Seventh Submittal – Denver Limo Services at Lockheed
Site Plan Amendment with Waiver and Replat
Application Numbers: **DA-2078-00**
Case Number: **1990-6023-03; 2017-3028-00**

Project: DLS, 91602

Re: First Technical Review – Denver Limo Services at Lockheed
Site Plan Amendment with Waiver and Replat
Application Numbers: **DA-2078-00**
Case Numbers: **1990-6023-03; 2017-3028-00**

C100.0

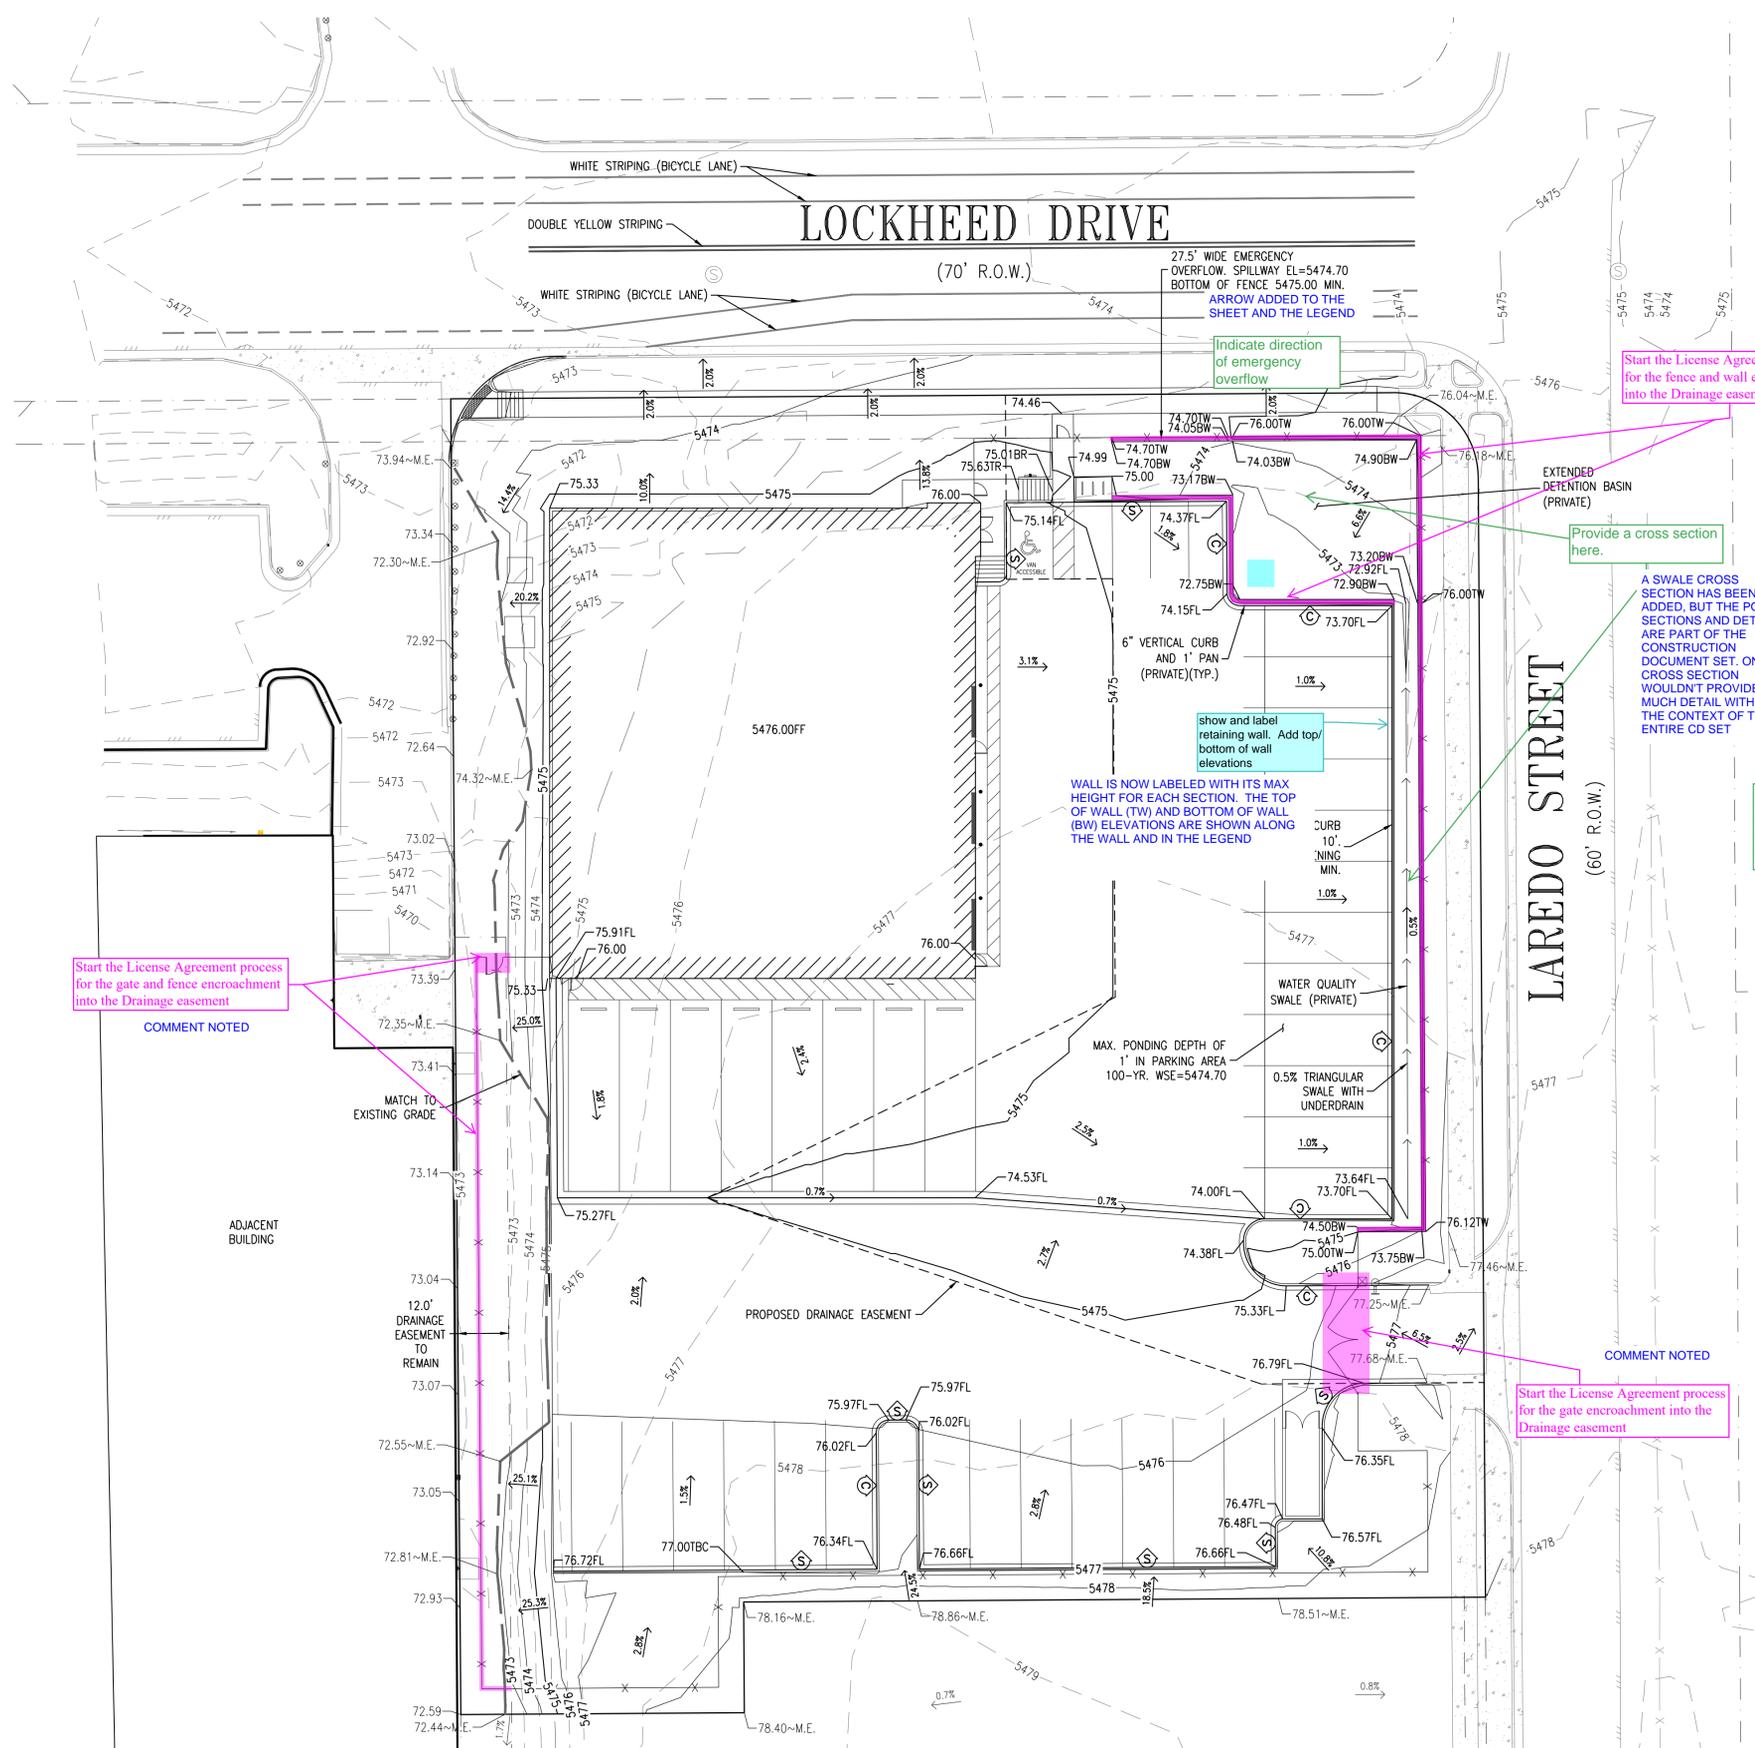
Start the License Agreement process for the fence and wall encroachment into the Drainage easement

Show the storm sewer on this sheet

Provide a cross section here.

Railing is required on all walls greater than 30". Please provide additional details of the retaining walls on site with max height or a height range

Add a note indicating if the storm sewer system is public or private and who will maintain it.

Start the License Agreement process for the gate and fence encroachment into the Drainage easement

Start the License Agreement process for the gate encroachment into the Drainage easement

COMMENT NOTED

ADDED

A SWALE CROSS SECTION HAS BEEN ADDED, BUT THE POND SECTIONS AND DETAILS ARE PART OF THE CONSTRUCTION DOCUMENT SET. ONE CROSS SECTION WOULDN'T PROVIDE MUCH DETAIL WITHOUT THE CONTEXT OF THE ENTIRE CD SET

WE WILL CALL OUT THE MAX. HEIGHT OF THE WALLS AS 42". THIS GRADING PLAN SHOWS THAT THE INTERIOR WALL IS NOT ABOVE 30" AND THEREFORE DOES NOT NEED A RAILING. THE EXTERIOR WALL HAS A FENCE ON IT WHICH ACTS AS A RAILING

THE STORM SEWER SYSTEM IS SHOWN ON THE UTILITY PLAN AND THE COMPONENTS ARE LISTED AS PRIVATE. WE WILL ADD A NOTE TO THIS SHEET AS WELL

COMMENT NOTED

COMMENT NOTED

C200.0

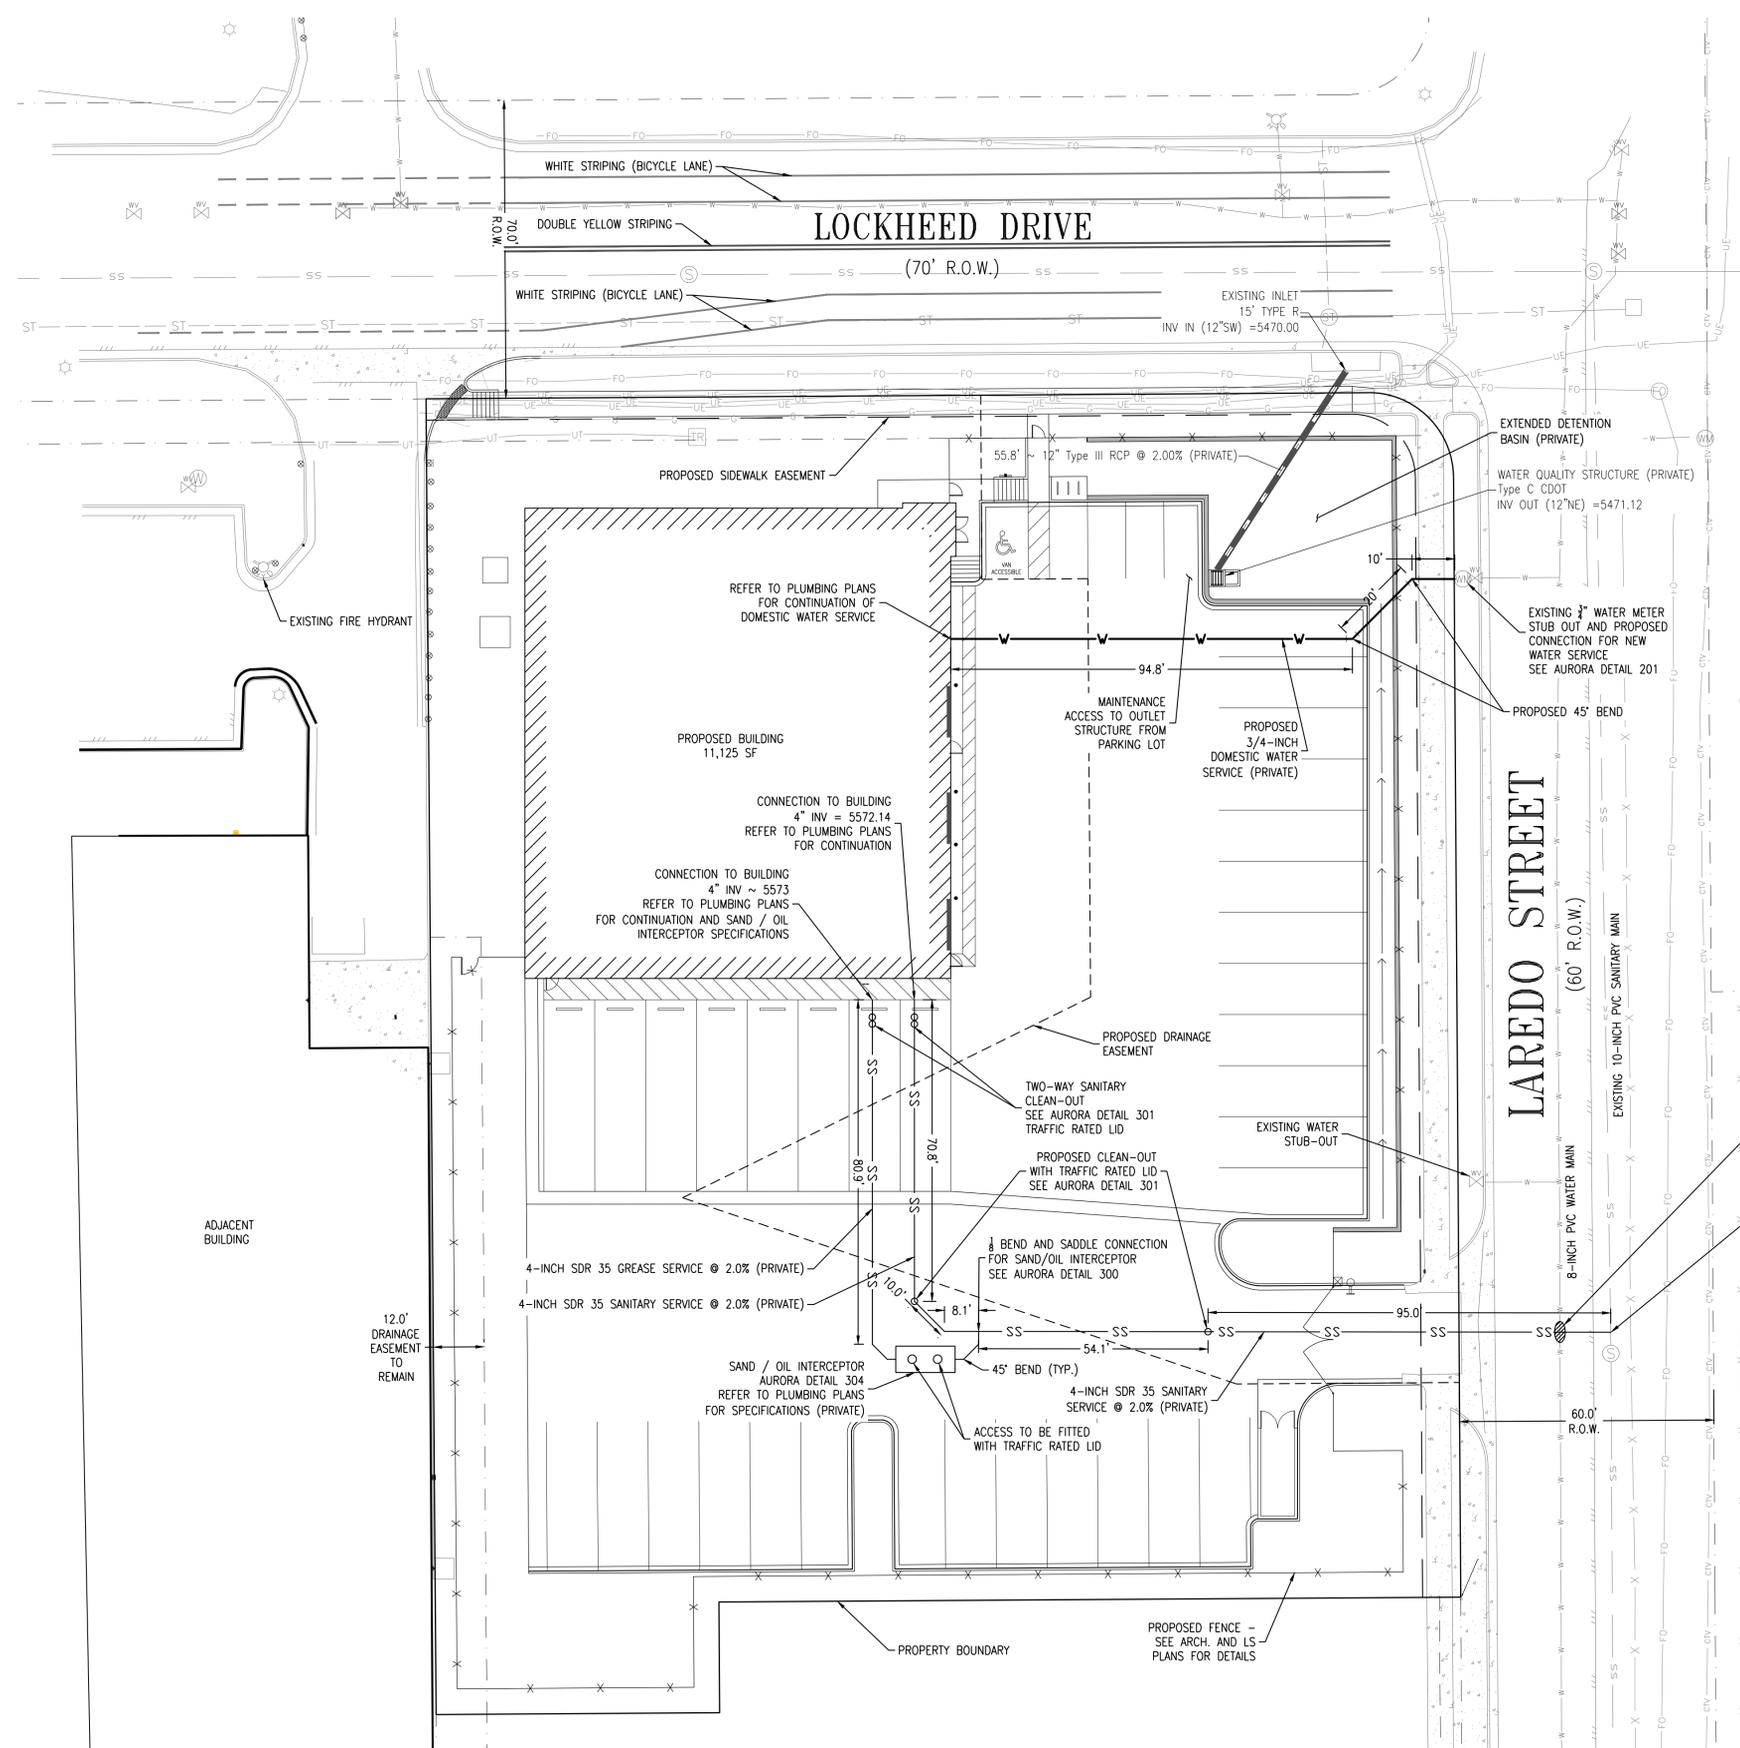
Add a note indicating if the storm sewer system is public or private and who will maintain it.

ADDED

A LANDSCAPE BOULDER N.T.S.

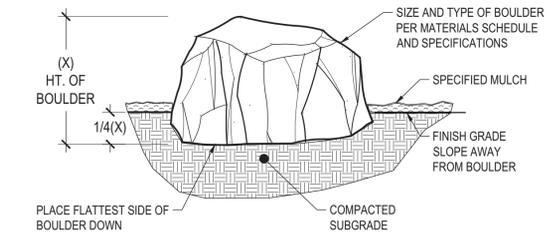
Add detail for Edger

ODG RESPONSE: STEEL EDGER DETAIL HAS BEEN ADDED

ISSUED FOR: SITE DEVELOPMENT PLAN
SHEET TITLE: LANDSCAPE PLAN
SCALE: AS NOTED
SHEET NUMBER: L200.0

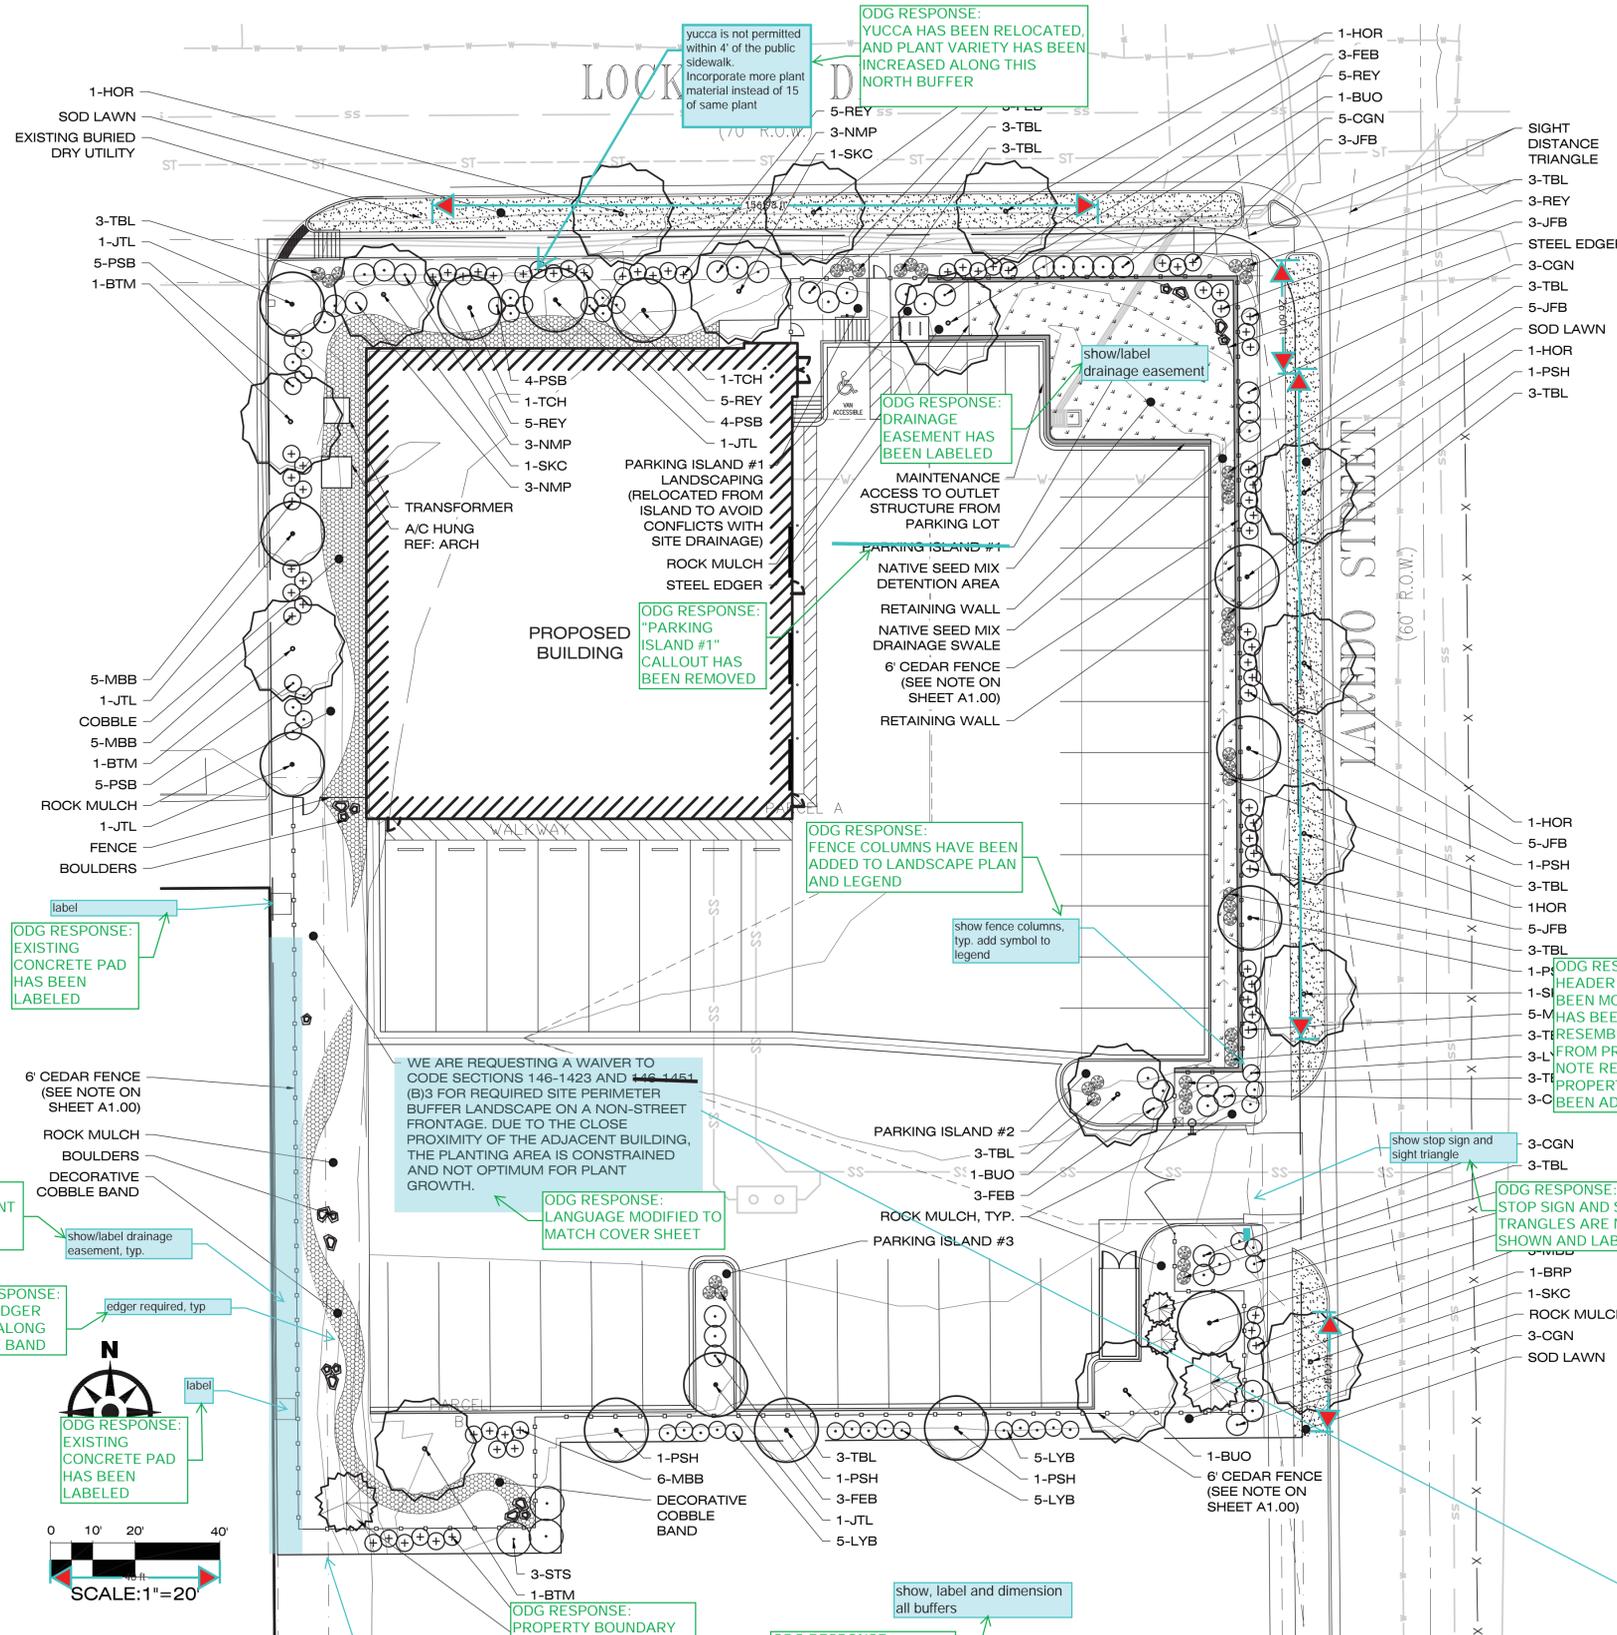
2B. Revise the title of the “Streetscape Calculations” table to “Standard Right-of-Way Landscape”. Revise the length of Lockheed Street frontage, which is greater than 106 feet.

2C. Add a column to the Buffer Landscape table to include the required and provided buffer widths. Identify whether any incentives were used to reduce the buffer width.

2D. Show, label and dimension all required buffers.

2E. Show, label and dimension all existing and proposed easements.

2F. Add the fence columns and retaining wall to the legend. Make sure all linework matches the symbol in the legend.

2G. Yucca is not permitted within four feet of the public sidewalk. Please replace of reposition and consider a more varied plant palette for the north buffer.

2H. Show the stop sign and sight triangle at the site entrance.

Outdoor Design Group Response: Language on the table on sheet L2.00 has been modified to read “Standard Right-of Way Landscape. The length of Lockheed Street frontage has been corrected from 106-feet to 157-feet.

Outdoor Design Group Response: A “Buffer Width” column has been added to the buffer landscaping table. At the top of the column, “Xeriscape” has been noted to indicate incentive.

Outdoor Design Group Response: Labels and dimensions have been added to all required buffers.

Outdoor Design Group Response: Labels and dimensions have been added to easements.

Outdoor Design Group Response: Fence column, steel edger, and retaining wall line types have been added to the legend. Line work have been modified for consistency and clarity.

Outdoor Design Group Response: Yucca has been relocated away from sidewalks, and replaced with a greater variety of plant materials.

Outdoor Design Group Response: Stop sign and sight triangles have been shown and labeled on plan.
